UCLH Phase 4 & PBT
External Works Section JJ KK

UCLH Phase 4 & PBT
Roof Package Location Plan

UCLH Phase 4 & PBT
Roof Package Plans - First and Third Floor
Level Courtyard Building

UCLH Phase 4 & PBT
Roof Package Plan - Fifth Floor Level Atrium Roof

R/F-03 Fifth Floor Plan
143142 1:100

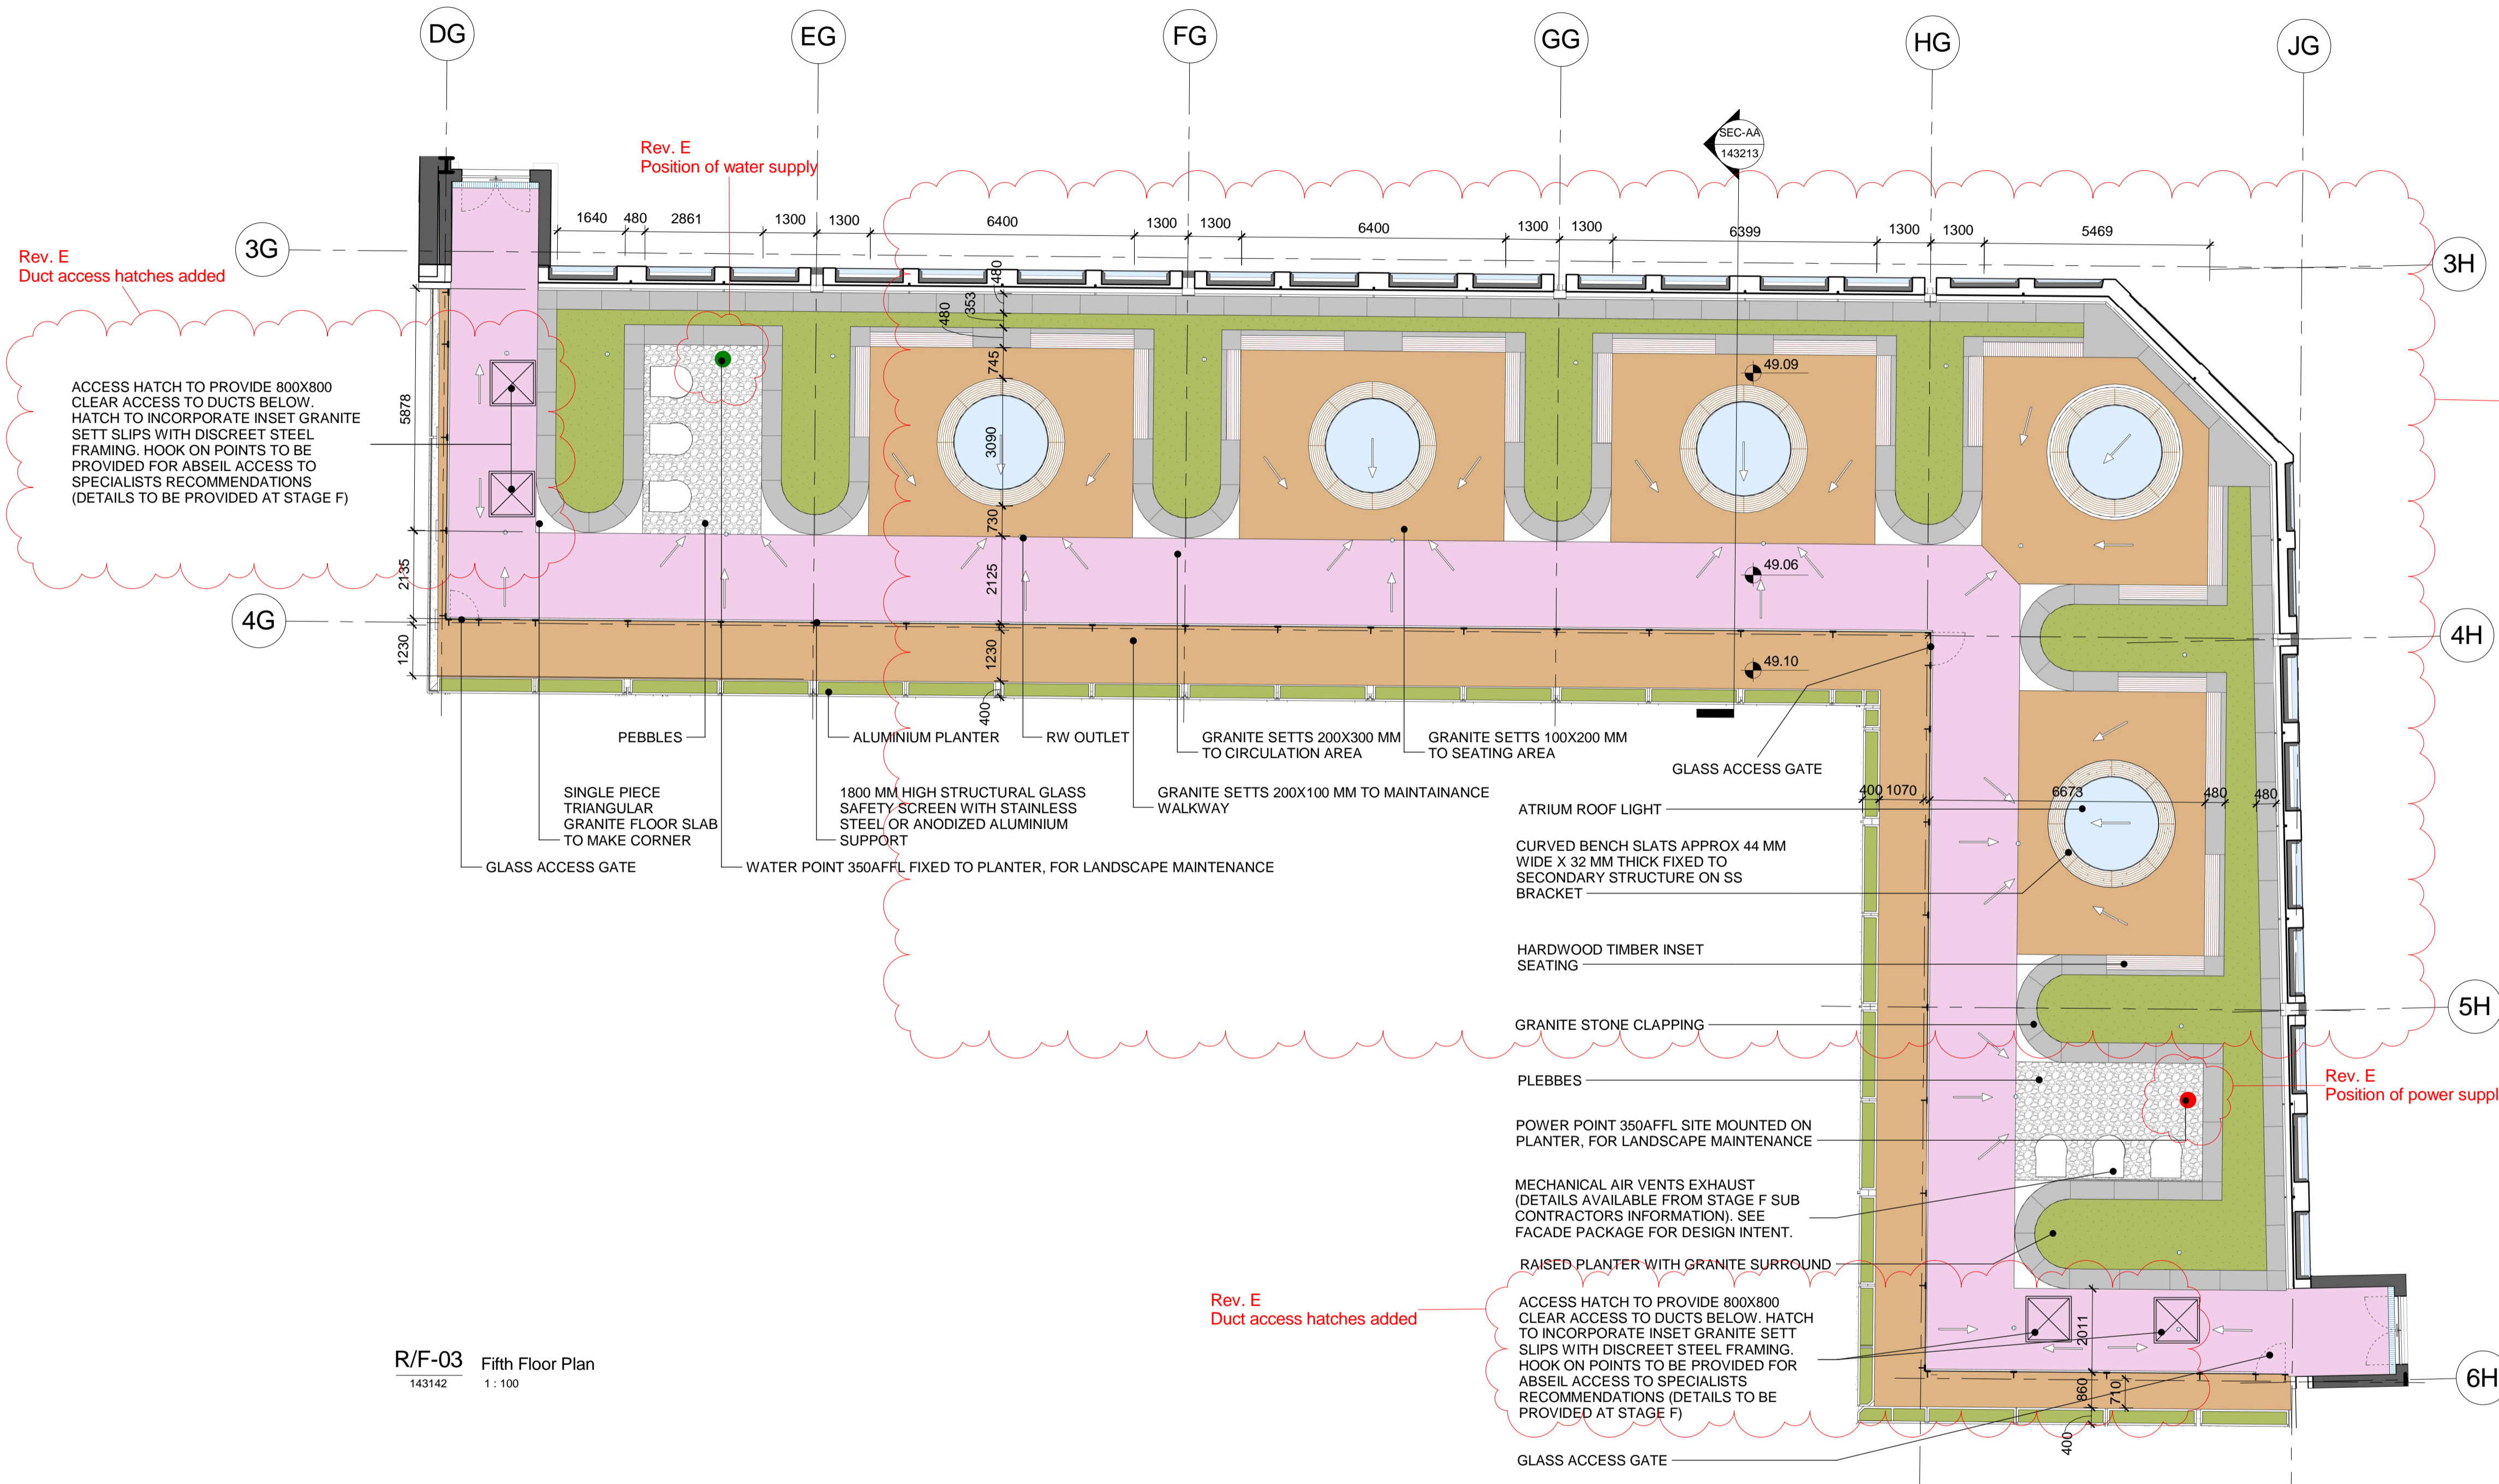
Rev. E Colour amended for clarity

Rev. E Finishes added to legend

Rev. E Landscaping finishes updated

Rev. E Note amended.

Rev. E Colour amended for clarity

Rev. E Position of power supply

Rev. E Colour amended for clarity

Rev. E Items added to legend

Rev. E Power and Water supplies added

Rev. E Duct access hatches added

Rev. E Duct access hatches added

ACCESS HATCH TO PROVIDE 800X800 CLEAR ACCESS TO DUCTS BELOW. HATCH TO INCORPORATE INSET GRANITE SETT SLIPS WITH DISCREET STEEL FRAMING. HOOK ON POINTS TO BE PROVIDED FOR ABSEIL ACCESS TO SPECIALISTS RECOMMENDATIONS (DETAILS TO BE PROVIDED AT STAGE F)

ACCESS HATCH TO PROVIDE 800X800 CLEAR ACCESS TO DUCTS BELOW. HATCH TO INCORPORATE INSET GRANITE SETT SLIPS WITH DISCREET STEEL FRAMING. HOOK ON POINTS TO BE PROVIDED FOR ABSEIL ACCESS TO SPECIALISTS RECOMMENDATIONS (DETAILS TO BE PROVIDED AT STAGE F)
